**DOCUMENT 00910**  
**ADDENDUM NUMBER 1**

PROJECT: High Level Booster Pump Station – DWSRF Project No. FS010069-05

OWNER: Hartselle Utilities  
Hartselle, Alabama

## **2.10 METAL AWNINGS**

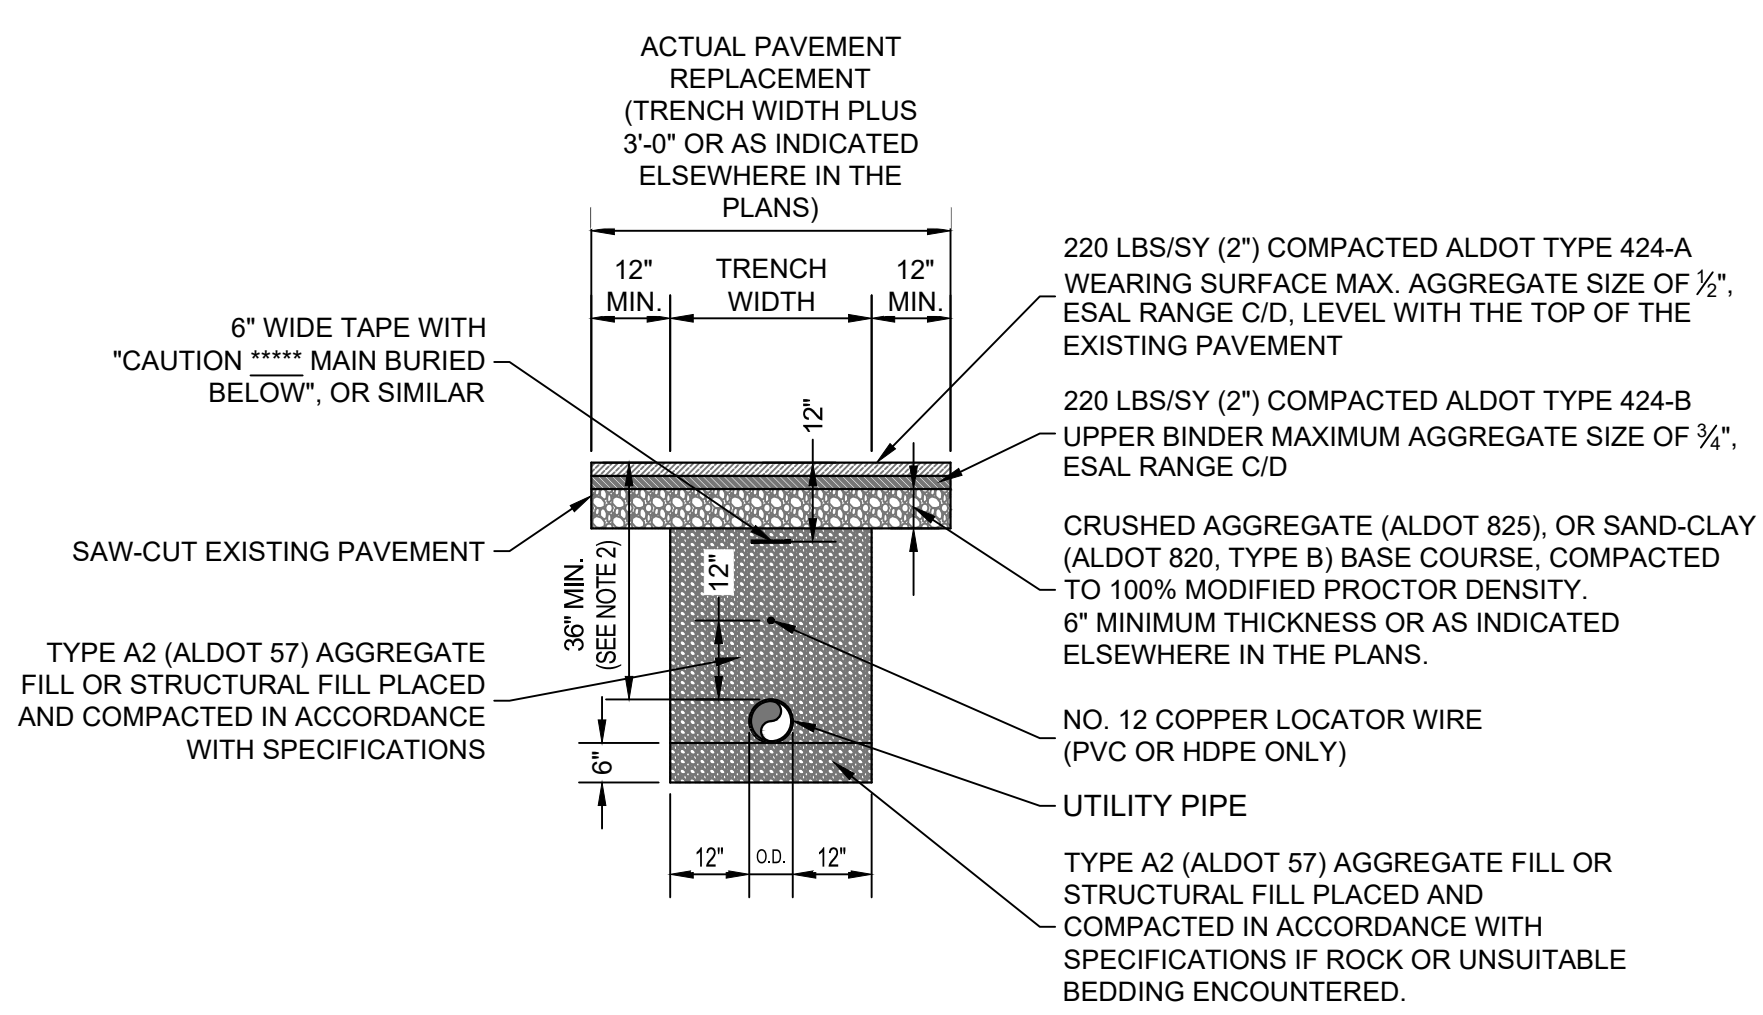
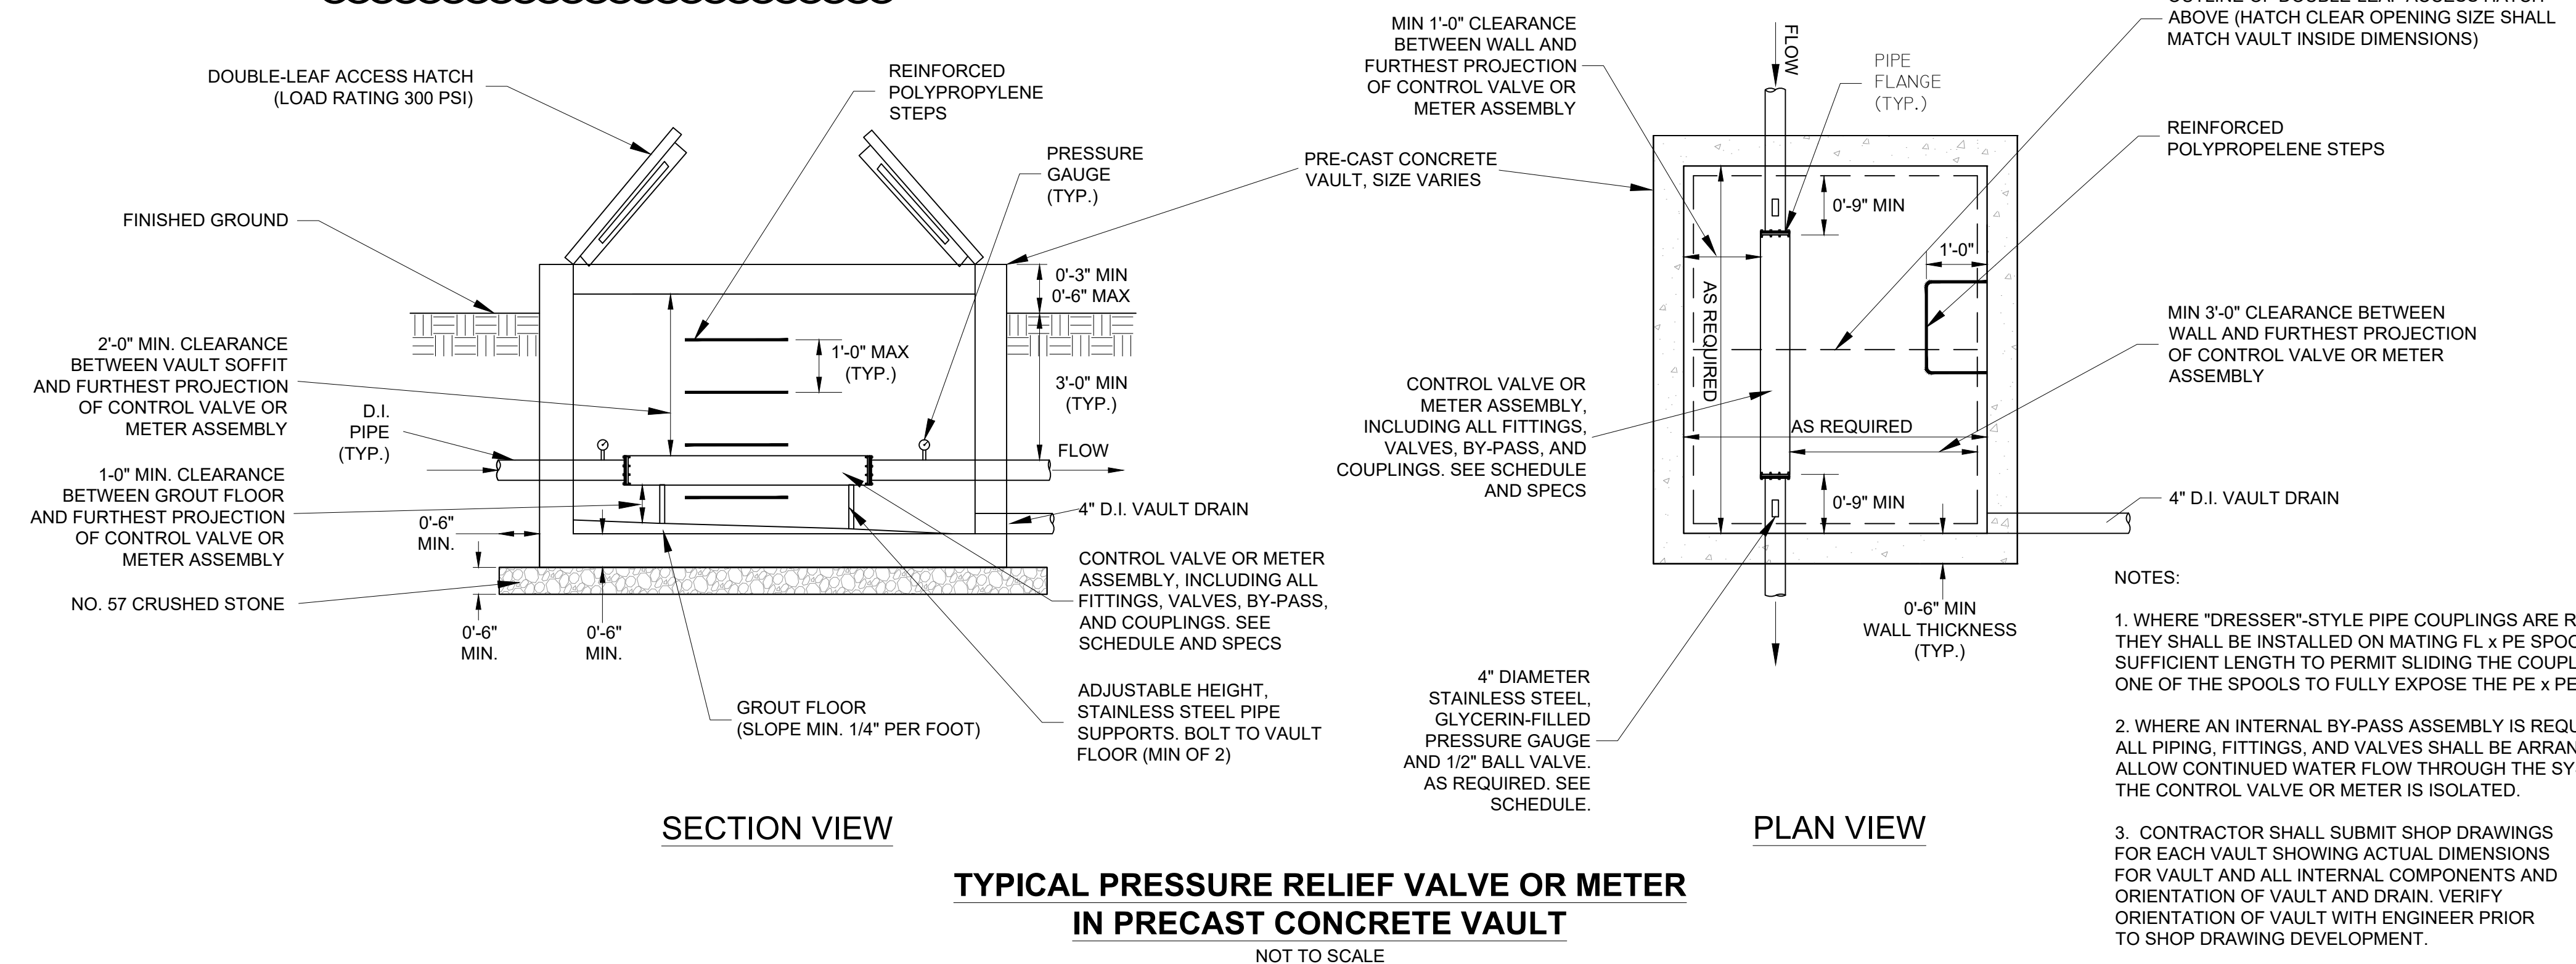
- A. Metal awnings shall be mounted to the building with a minimum of two (2) braces. Braces shall be spaced evenly.
- B. Metal awnings shall have a minimum projection of 36" from the building and shall be a minimum of 42" in width.
- C. A watertight seal shall be installed between the awning flashing and building.
- D. All fasteners and anchors required for mounting and assembly shall be stainless steel.
- E. Awning color shall be selected by the Owner from manufacturer's full range of actual material samples.

C:\USERS\CASEY.HELLUMS\CDGE\000.001\CDG ENGINEERS & ASSOCIATES\UTILITY PRACTICE AREA - DOCUMENTS\PROJECT DRAWING FILES\R906817002-HU-HIGH LEVEL BOOSTER PUMP STATION\DRAWINGS\C-800S\_DETAILS.DWG

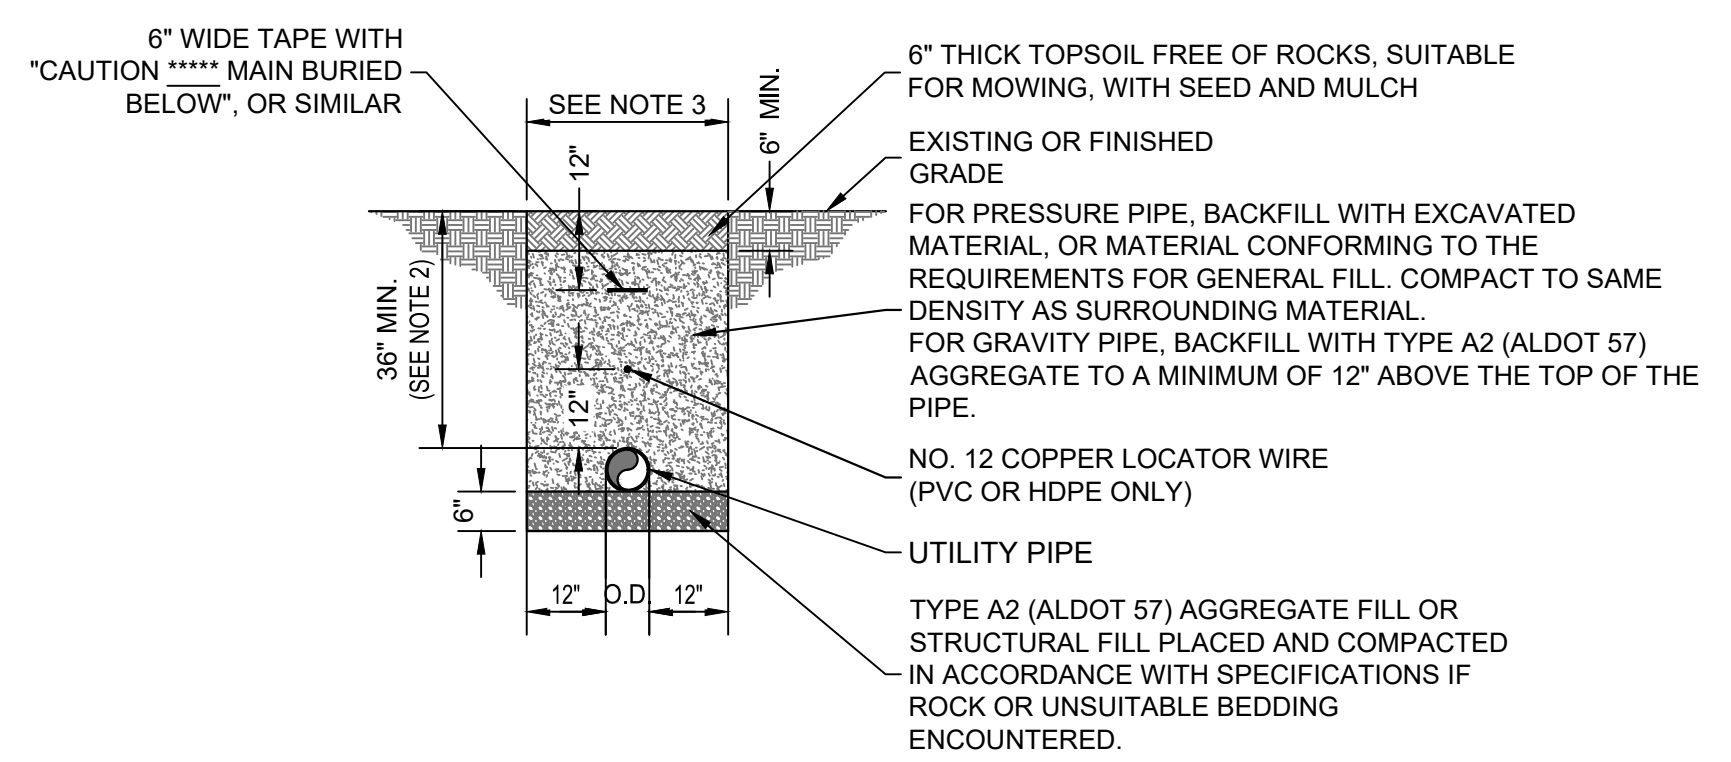
1. Sheet C-804 – Project Details
  - a. The 12” Mag Flow Meter & Vault shall have an internal piping size and main equipment nominal size of 12”.
  - b. A clearance of 18” shall be required to any pipe, valve, fitting, or meter assembly from the reinforced polypropylene steps.
